- 5. East Oyster Cove Subdivision; KPB File 2022-047
Fixed Height LLC / Alaska Mental Health Trust Authority
Location: Northeast of Jakolof Bay Road
Remote Area**

ITEM 5 - EAST OYSTER COVE SUBDIVISION

KPB File No.	2022-047
Plat Committee Meeting:	May 9, 2022
Applicant / Owner:	Alaska Mental Health Trust of Anchorage, AK
Surveyor:	Andre Kaeppele, Buku Saliz / Fixed Height LLC
General Location:	Remote, Oyster Cove, Kasitsna Bay

STAFF REPORT

Vicinity Map

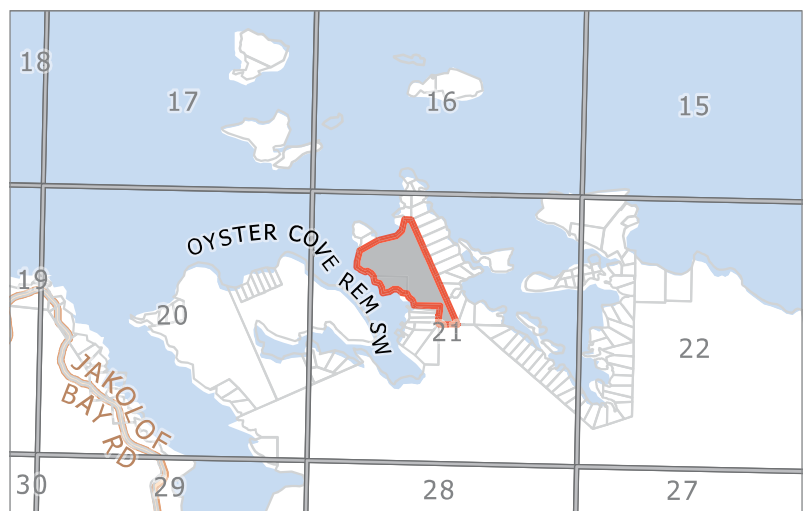
Staff recommendation: *Provide a depiction of the boundary and label the Kachemak State Park.*

A PLAT OF
EAST OYSTER COVE SUBDIVISION

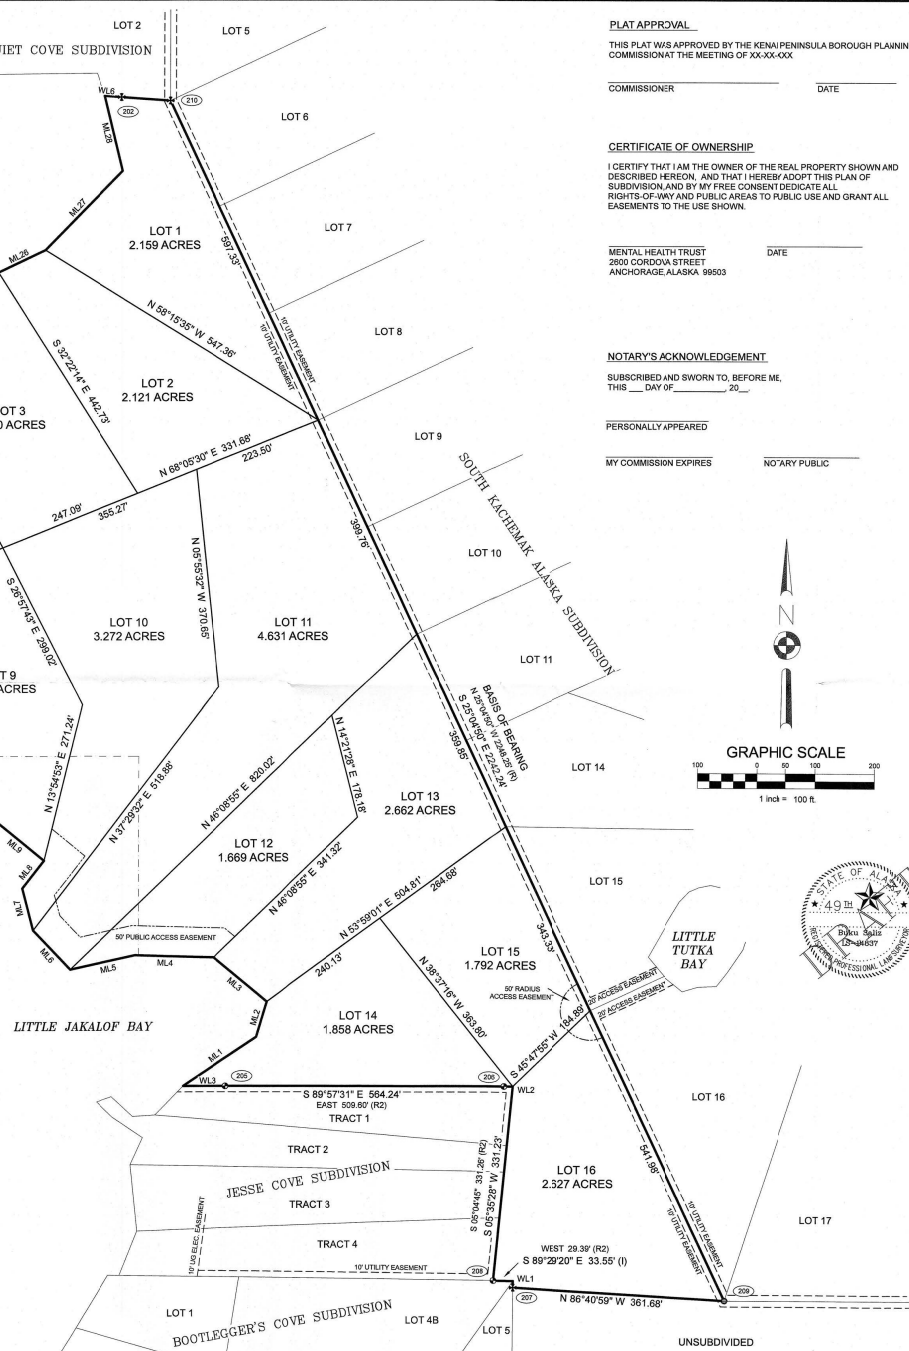
Several easements are depicted on neighboring properties. **Staff recommends** those depictions and labels be removed from the final plat.

- Owner name should include Alaska Mental Health Trust.
- The KPB Assessing information has a different address for Alaska Mental Health. Verify the address they wish to have present on the plat.
- The recording district is required within the title block. It can be added to the location description.
- Bootlegger's Cove Subdivisions do not need to be included as they are considered within the southern half of the section. Please remove and this will match the Certificate to Plat.
- For Jesse Cove Subdivision and Quiet Cove Subdivision, include their plat recording numbers.
- Update the acreage.

Staff recommendation: *The subdivision for Lot 4B to the south is Bootleggers Cove No. 2. Update the labels to differ it from the other lots from the original Bootleggers Cove Subdivision.*

Staff recommendation: *Although from separate subdivisions, adjacent lot numbers that match should be avoided. Lot 15 abuts the entire length to another Lot 15 as does Lot 16. Review the lot numbers and adjust to avoid the same numbering if possible.*

Staff recommendation: *Adjust so adjacent lots from neighboring subdivisions do not share the same lot number if possible.*

- *The certificate of ownership should be revised to read on behalf of the Alaska Mental Health Trust. "I certify that the Alaska Mental Health Trust is the owner of the real property shown and described hereon, and that on behalf of the Alaska Mental Health Trust I hereby adopt this plan of subdivision and by my free consent dedicate all rights-of-way and public areas to public use and grant all easement to the use shown."*
- *The title of the signer on behalf of the Kenai Peninsula Borough should be changed to "Authorized Official"*
- *On the certificate of ownership signature line, we request the authorized person's name and title be added or provide an area where they can neatly print the information.*
- *Correct the Notary's Acknowledgement so it is an acknowledgement instead of a combination of an acknowledgement and a jurat.*
